Immingham Eastern Ro-Ro Terminal (“IERRT”)

PINS Ref: TR030007

Deadline 7 submissions of the IOT Operators

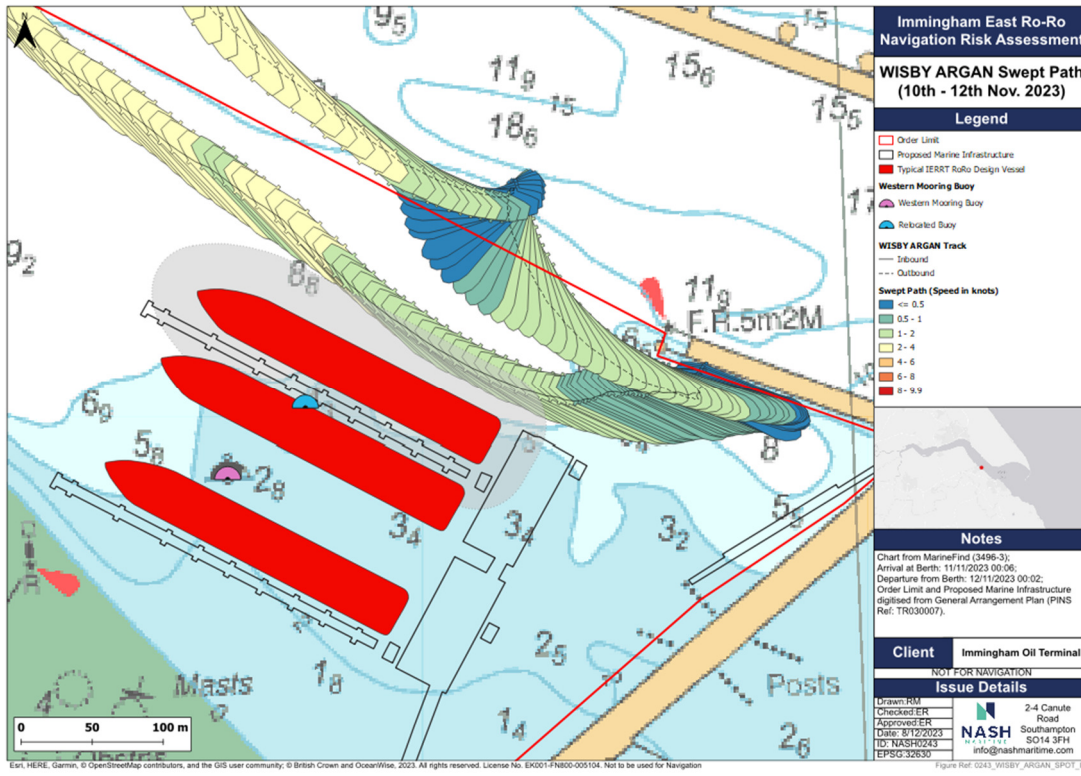
65. The IOT Operators share concerns regarding poor engagement by the Applicant regarding the lack of opportunity to understand and comment on the November simulations. This is strongly underscored by the failure to assess the likely significant effect of the design vessel which has a materially greater mass than those modelled in the simulations, as outlined above.
66. During ISH5, run 30 was raised with respect to the simulated run inward to IOT8 in SW 30 knots wind (figure below).

67. In response to these questions, ABP indicated that having conducted the simulation run at 30 knots wind, it 'emerged' that there was an IOT hard cut off for on berth wind of 30 mph or 26 knots. The IOT Operators wish to provide clarity on this to avoid the mistaken assumption that the simulation run wind was therefore 'out of limits', and so not give sufficient weight to the run. The wording of text attached from IOT SMS paragraph 2 shows that an arrival in 30 knots or 36 mph of mean wind is perfectly feasible, does occur and also mentions the use of a tug forward.

68. Additionally, guidelines refer to mean wind and the reality is that in such wind conditions there would be a likely variance (gusting) of around 10 knots. Therefore, operating in gusts exceeding 40 mph would be commonplace. This has not been simulated. Rather, only flatline mean wind was simulated which cannot and does not represent reality.

69. The IOT Operators consider that, with or without a ferry in place at IERRT1, an upwind approach is required to keep a tanker sufficiently far south of the line of IOT8 to deal with the sudden exposure to the full force of the wind, at exactly the worst time, when reducing speed on the final approach to the berth. It must also be considered that a

forward 40-50t tug needs room to work perpendicular to the bow of the vessel with a suitable length of line allowed to be able to deliver lift without adding to the tanker's headway. In this scenario, as the ship reduces speed at the point indicated by the first 10-minute red ship shape above, the immediate effect of the wind is demonstrated by the significant northerly set.

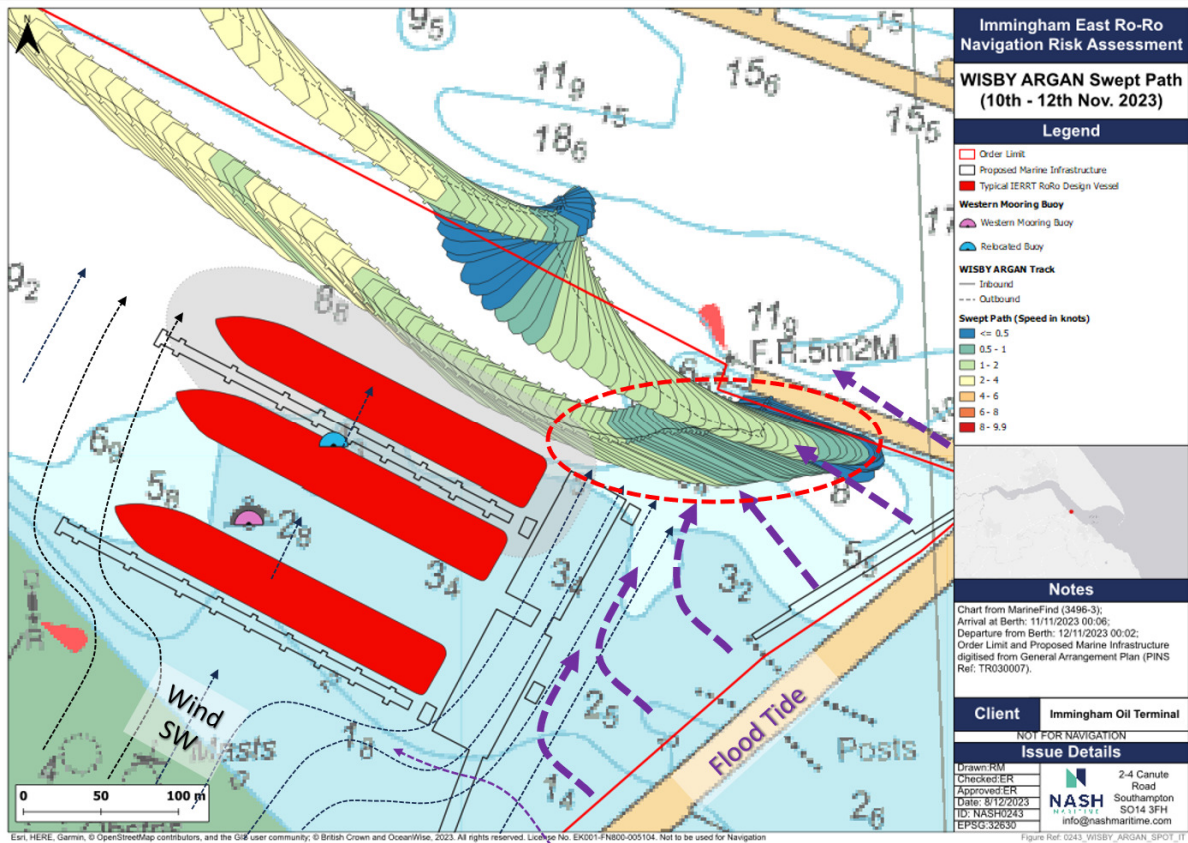
72. With the IEERT and a moored RoRo in place the required approach path width and angle is critically reduced (much more so than with the IOT Western Barge Mooring buoy being out of place – which it is understood has been like this for several years), as Masters and Pilots of Coastal tankers would typically require two beams widths clearance from other objects such as a moored vessel (the figure below shows a 32m buffer in grey for the IERRT RoRo vessel indicating the necessary minimum searoom buffer for safe seamanship).

73. With the IERRT in place and IERRT RoRo vessels alongside, the complexity and difficulty of berthing is significantly increased due to:

- increased tidal flow speeds and a more acute tidal flow onto the IOT berth (noting that IOT Coastal Tankers only berth on the flood tide); and
- wind fluctuations (lulls and gusts) from shielding brought about by IERRT vessels alongside IERRT.

74. In the annotated figure below, wind (dashed black arrows) and tidal arrows (dashed purple arrows) clearly demonstrate confluence of these forces would be on a coastal tanker in the final stages of berthing on IOT Finger Pier berth 8 (see dashed red ellipse). This is the very point that a bow tug would be hindered the most by the limited searoom with the IERRT pontoon and needed the most.
